SUBJECT **Update requested to the Auckland Unitary Plan (Operative in Part 2016) (AUP)**

Reason for update	Private Plan Change 98 to be made operative
Chapter(s)	Chapter I Precincts GIS Viewer planning maps
Designation only	
Designation #	Name & RA
Locations:	
Lapse Date	
Purpose	
Changes to text (shown in underline and strikethrough)	<p>Amendments are required because Private Plan Change 98 is to be made operative. The Decision on plan Change 98 is shown in Attachment 1.</p> <p>Chapter I Precincts South:</p> <ul style="list-style-type: none"> Add new precinct – I459 Pukekohe East-Central 2 Precinct. <p>Amendments shown in Attachments 2 and 3.</p>
Changes to diagrams	One new precinct plan as shown in Attachments 2 and 3.
Changes to spatial data	<p>Amend GIS Viewer planning maps:</p> <p>AUP Zones</p> <ul style="list-style-type: none"> Rezone 50 Pukekohe East Road and 47 Golding Road, Pukekohe from Future Urban Zone to Residential – Mixed Housing Urban Zone. <p>AUP Management Layers</p> <ul style="list-style-type: none"> Add a new precinct – Pukekohe East-Central 2 Precinct to 50 Pukekohe East Road and 47 Golding Road. <p>Amendments shown in Attachment 4.</p> <p>AUP Appeals and Plan

IXXX.10.1. Precinct Plan 1

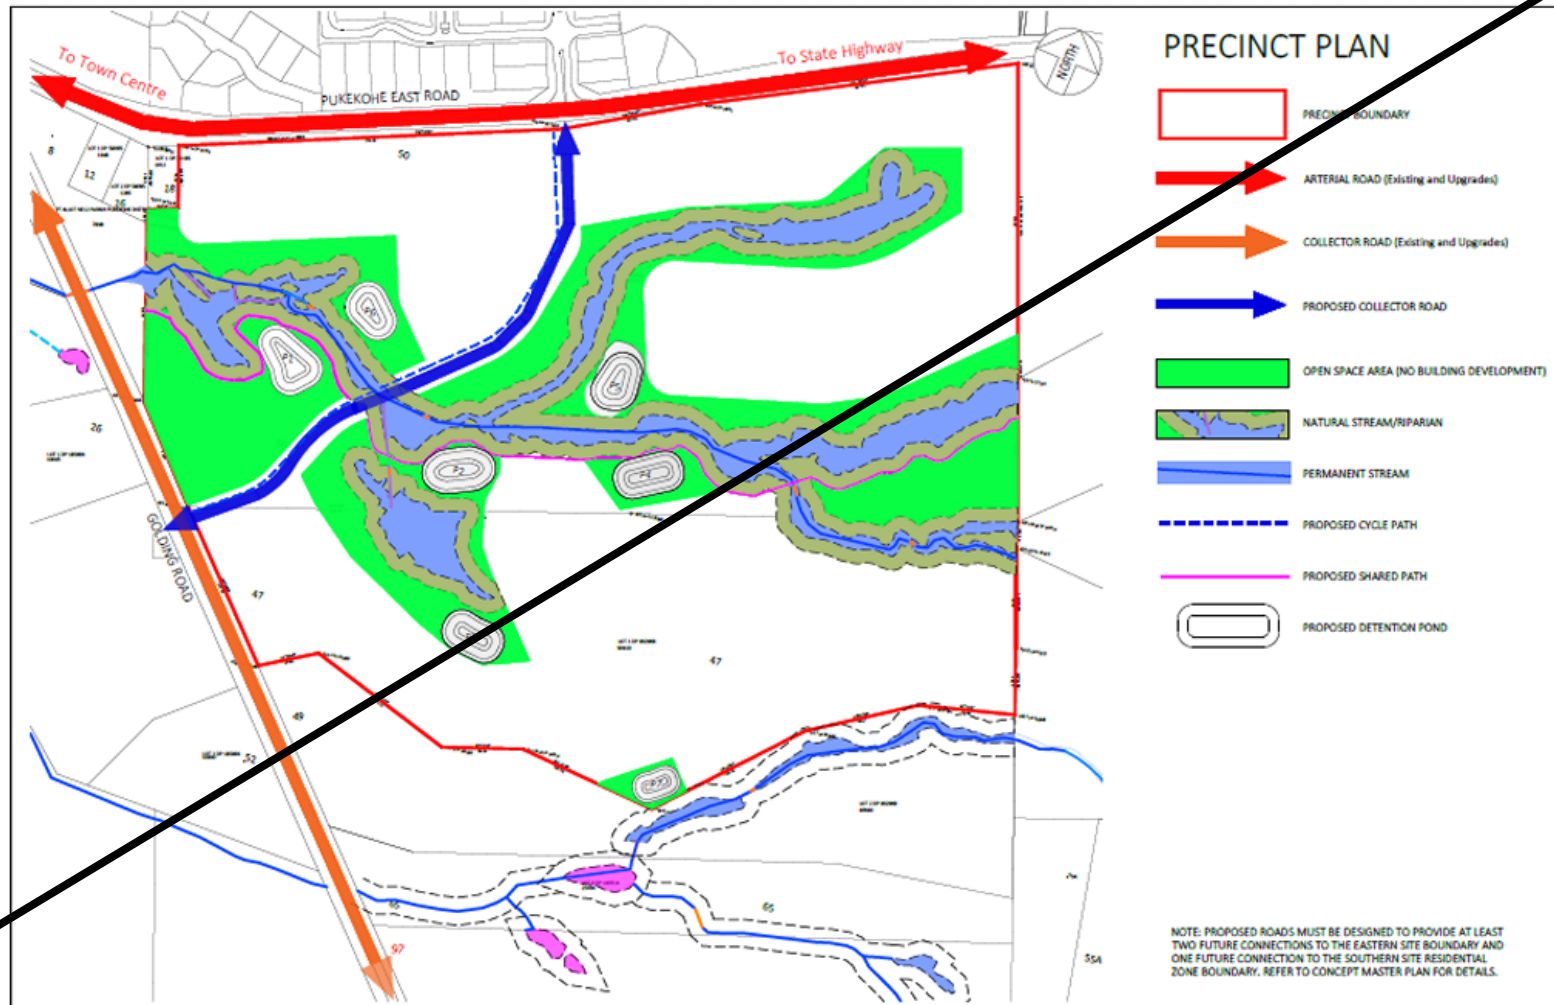
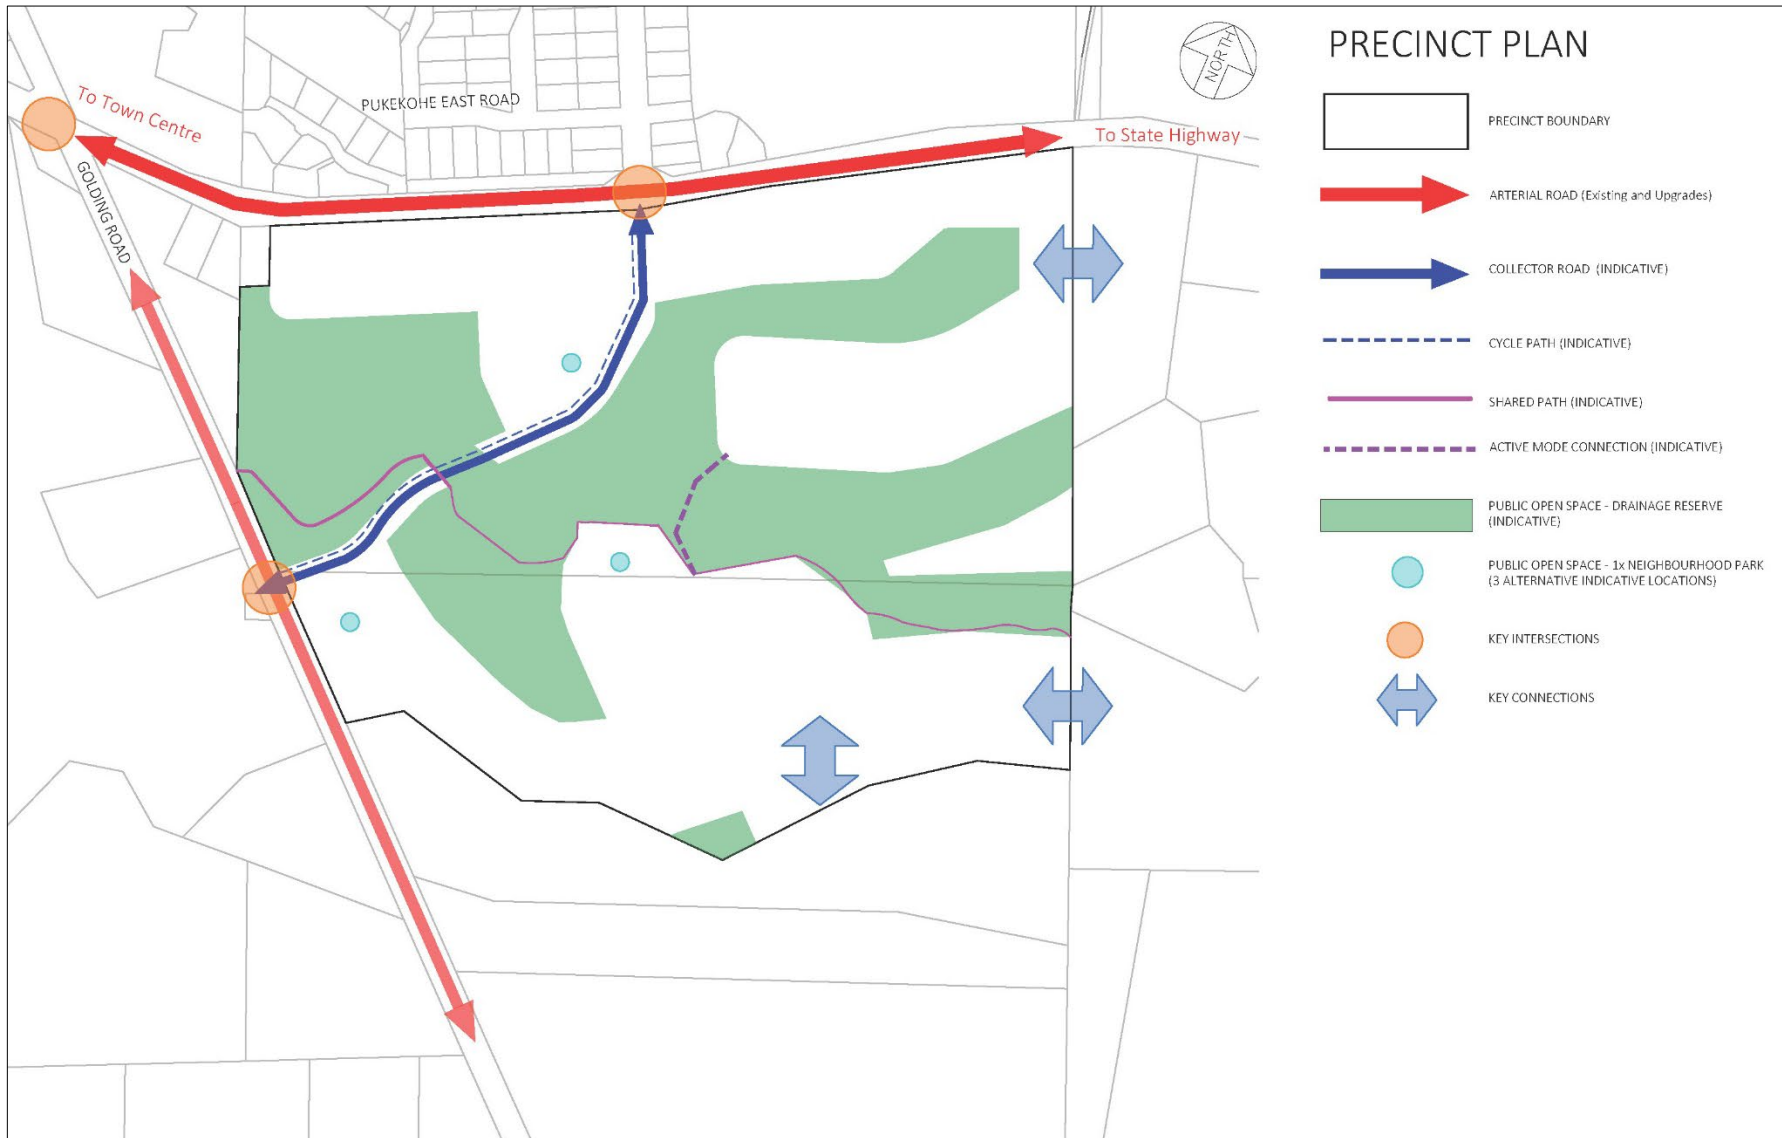
- (e) *The Precinct Plan is recommended to be amended. None of the amendments are substantive, however they have been provisionally checked with the Applicant who agrees with all the changes. The*

Applicant has now amended the precinct plan to reflect the amendments discussed. The revised precinct plan has been inserted into the two sets of precinct provisions attached. For clarity, a separate precinct plan marked up with comments is attached explaining the recommended changes.
